Fatullah Apparels

31st May & 25th August 2021

Building Information

Observations

Footing schedule

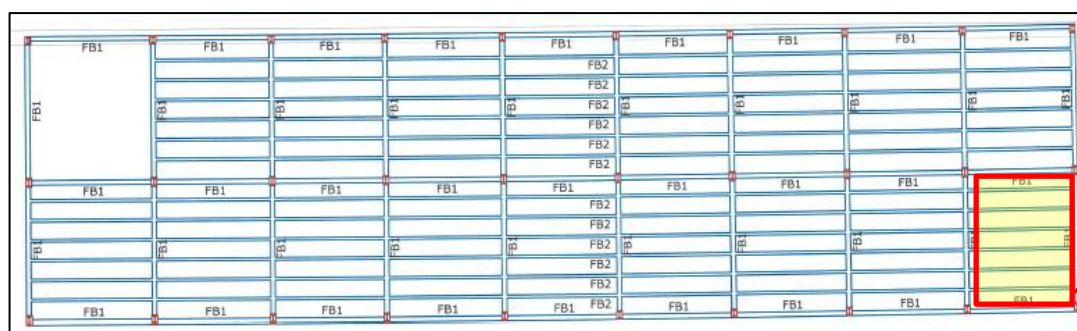
Cursory calculation indicates that the stress in some foundations exceeds normal design limit. Considering 2 kPa live load on typical floor & 1 kPa live load on roof top. The footings were found stressed in excess of normal design limit against the soil bearing capacity available from Geotechnical investigation report. Building engineer is required to carryout foundation adequacy check to justify the load carrying capacity.

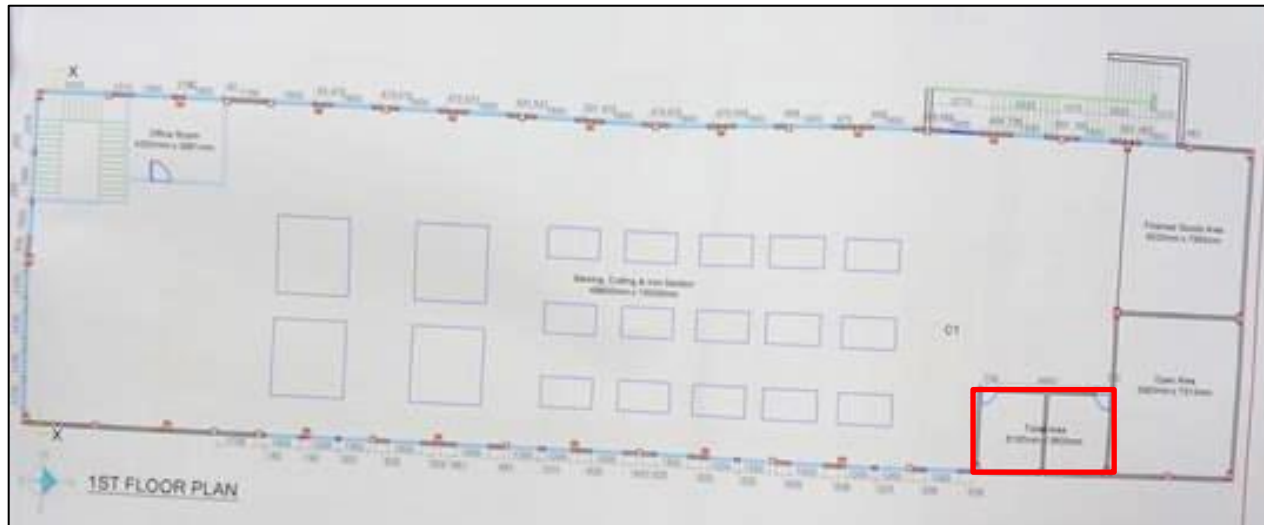
Connection Details are not available in as-built drawing

The factory engineer is required to survey the structures and prepare as-built drawings complying with section 1.9.1.2 of BNBC.

Toilet build-up information has not been provided

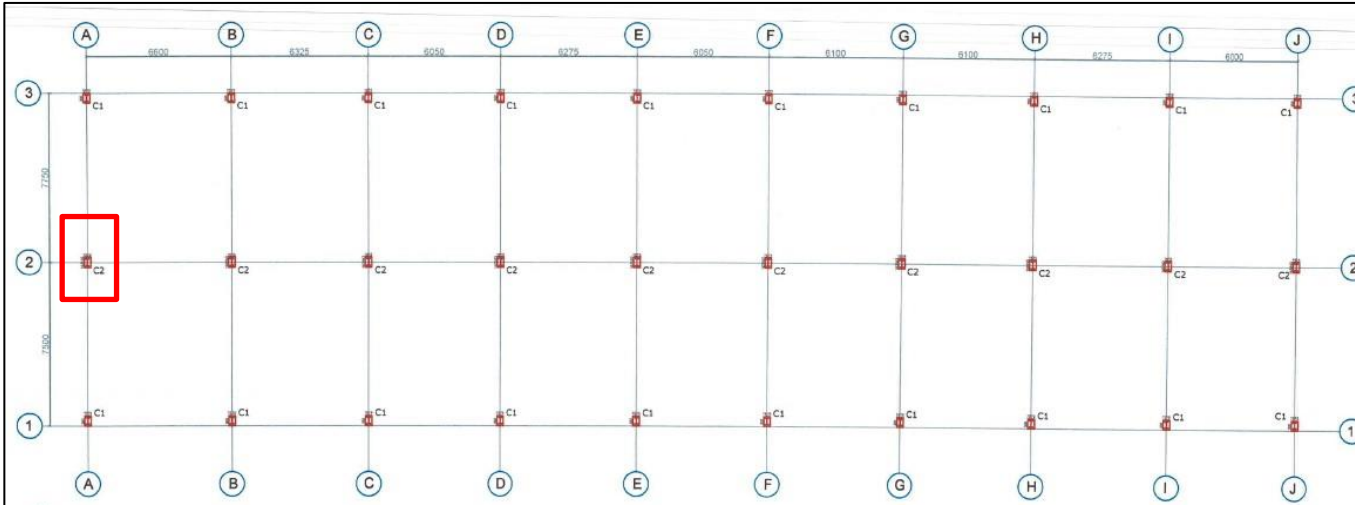
Toilet build-up was found at 1st floor which has not been shown in drawing. The build-up was found 100mm to 250mm. Also, the arrangement of toilet zone wall & number of toilet do not match with as-built drawing.

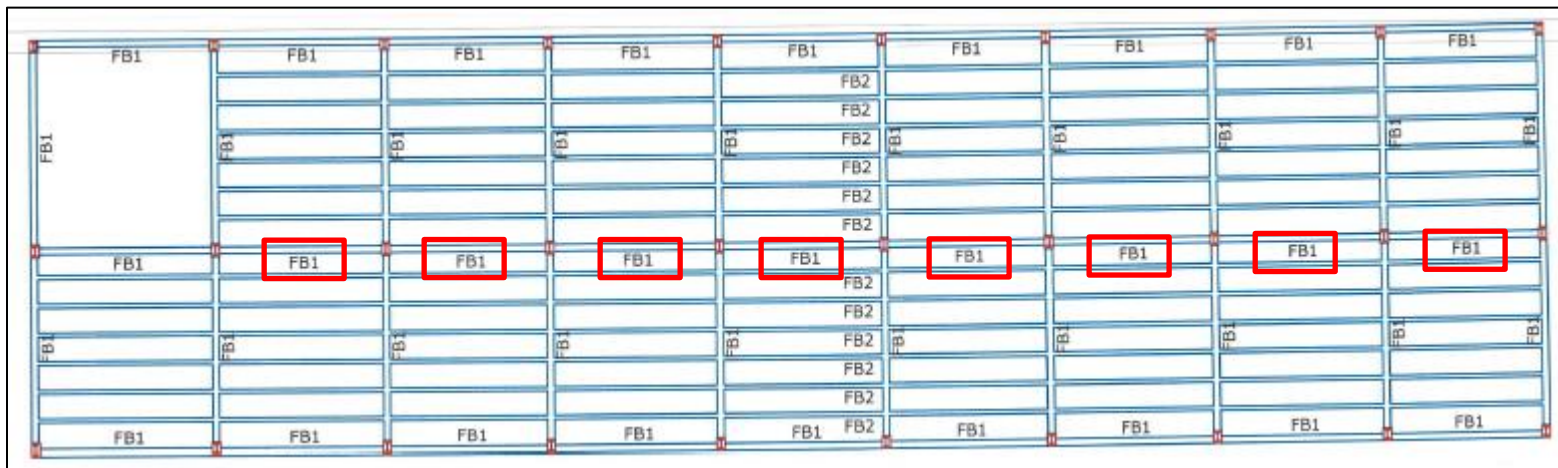
The steel column (C2) at marked grid at 1st floor was found W:300XF:150(6) instead of W:325XF:150(10)

In Steel column schedule;
C2 column has been
shown
W:325(8)XF:150(10)

At site the web was measured 300mm, Flange 150mm & flange thickness 6mm

The size of steel beam FB1 at marked locations was found W:180XF:100(6) instead of W:325XF:150(10)

At site the web was measured 180 mm and Flange 100mm

In Steel Beam schedule; FB1 beam has been shown W:325(8)XF:150(10)

The factory engineer is required to survey the structures and prepare as-built drawings complying with section 1.9.1.2 of BNBC.

Crack found in external RC stair

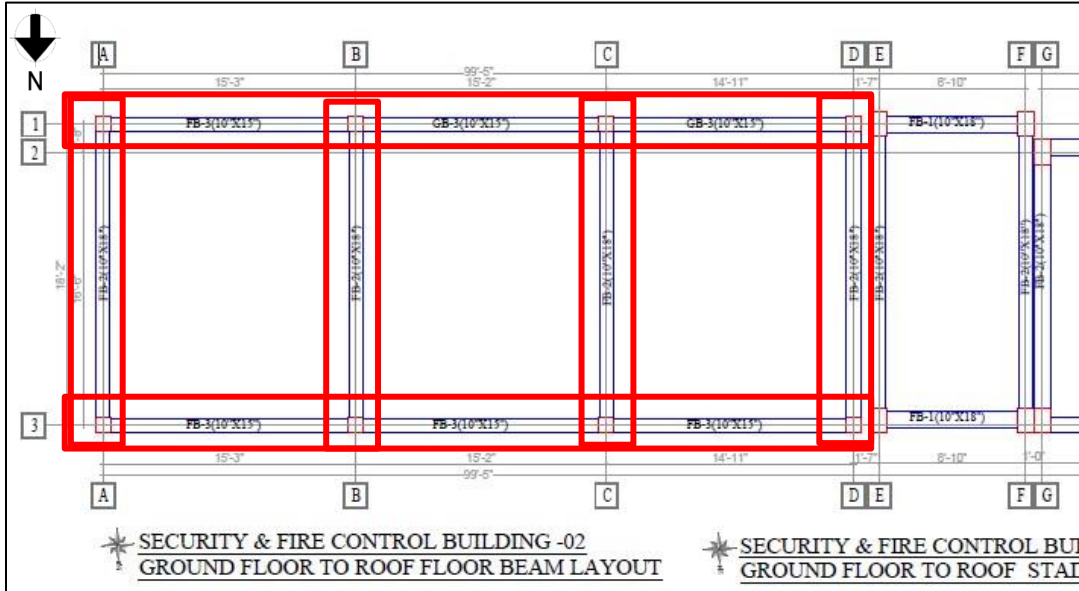
Crack was found in several locations of RC stair. Factory engineer is required to investigate the cause of crack and repair the crack as per recommendation from investigation report.

Water ponding at roof

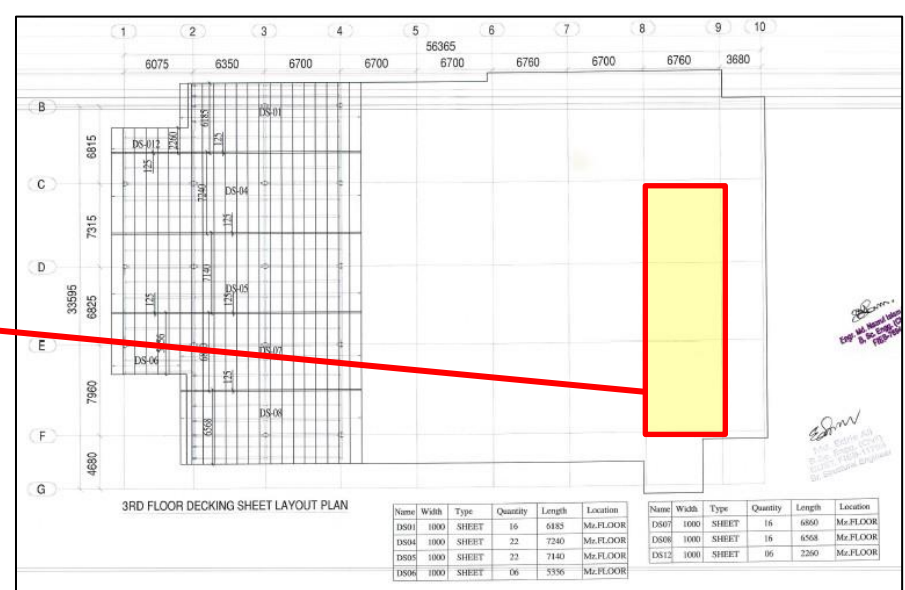
Water ponding was found at roof area. The water drainage system and adequate sloping was not found. The factory engineer is required to develop proper drainage system with adequate sloping on the mentioned area.

Undocumented partial storey at roof

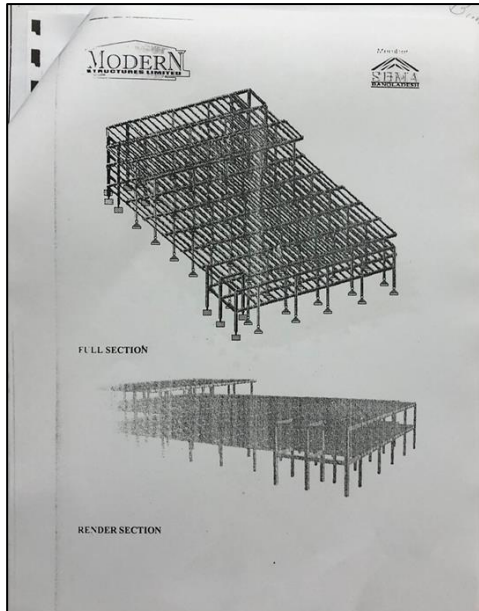
At roof a partial storey having 3X1 panel (marked location) has been constructed. But in as-built drawing & design report which has not been considered.

As per BNBC, every building or structure designed shall have its design documents prepared in accordance with the provision of Section 1.9.1. The design document shall include a design report, and a set of structural drawings, which shall be prepared in compliance with section 1.9.1.1 and section 1.9.1.2 as per BNBC. Revise the provided design report and load plan based on the observation.

Column Layout Plan. The details of the structural members along the grid-1 has not been provided in as-built drawing.

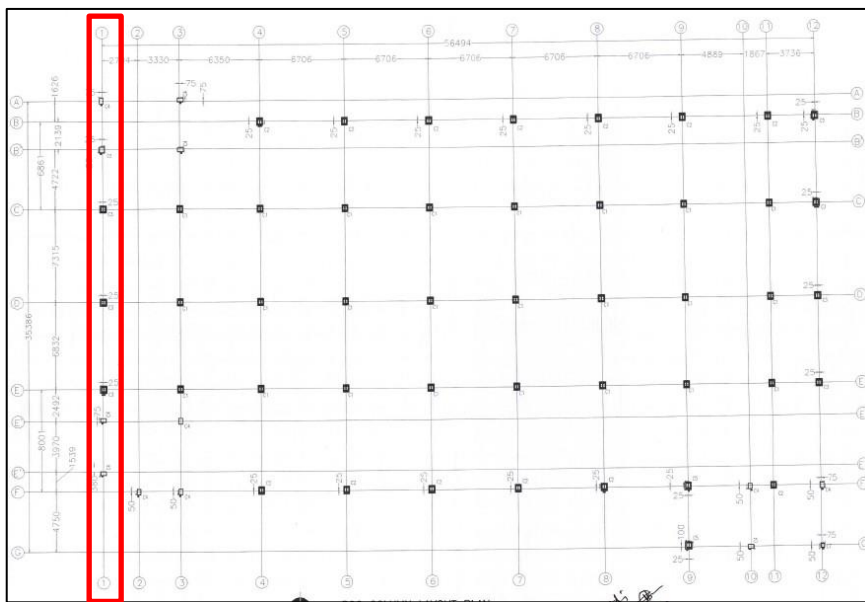
The details of the bracing was not found in as-built structural drawing.

Undocumented water tank was found at roof top.

Factory engineer is required to survey the whole structure and update the as-built drawings.

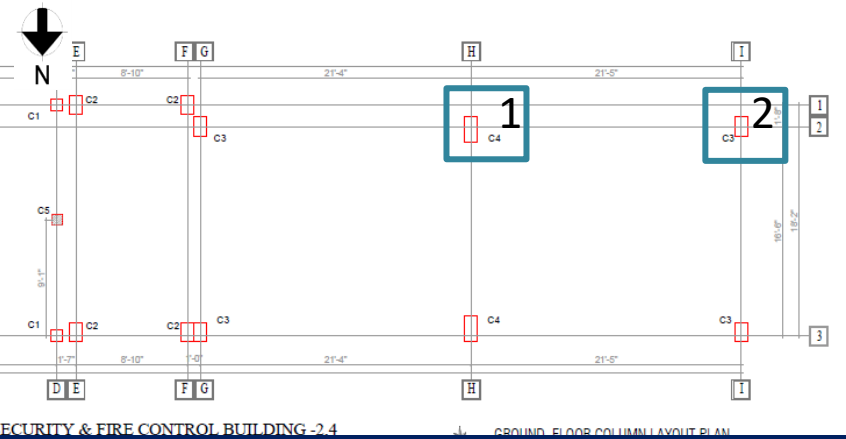
Corrosion in steel member was observed in various locations. The building engineer to investigate the reason of corrosion and suggest proper remedial measure accordingly.

SECURITY & FIRE CONTROL BUILDING -2.4 GROUND FLOOR COLUMN LAYOUT PLAN

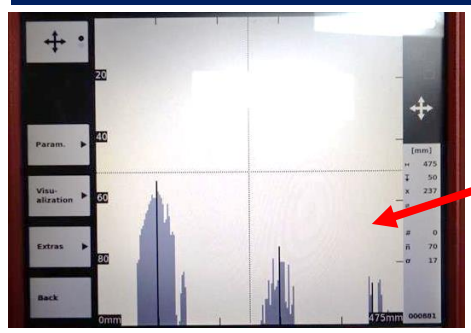
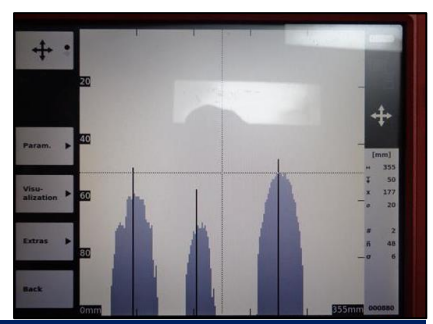
Column schedule shows total 14 numbers of re-bar for C4 column and 10 numbers of re-bar for C3 column.

From the ferro scan 10 nos re-bar was found for C4 column instead of 14 nos

From the ferro-scan only 3 number of re-bar at long face of C3 column found was found instead of 4 numbers re-bar.

Factory engineer is required to survey the whole structure and update the as-built drawing.

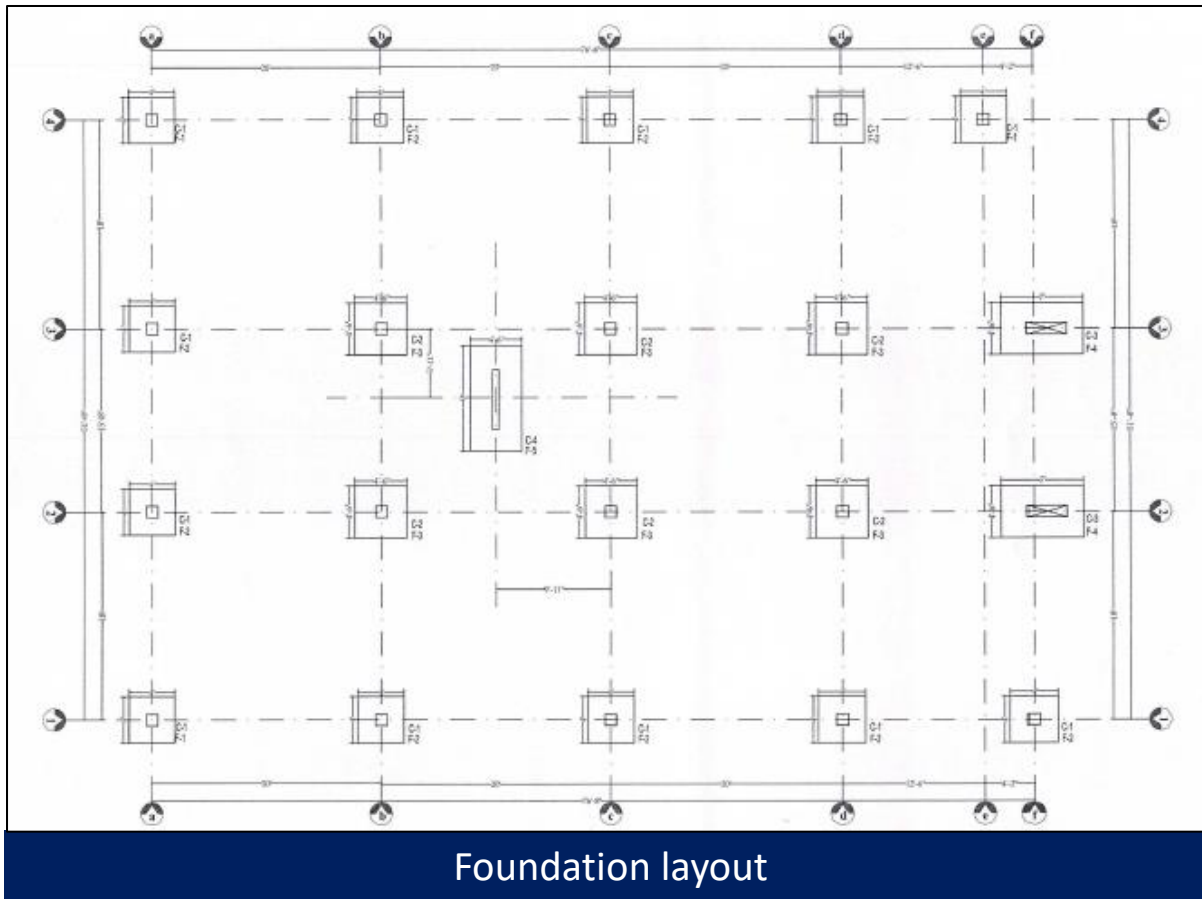
Exposed reinforcement was found on roof top columns. Factory engineer is required to take necessary measures to prevent the corrosion in exposed rebar.
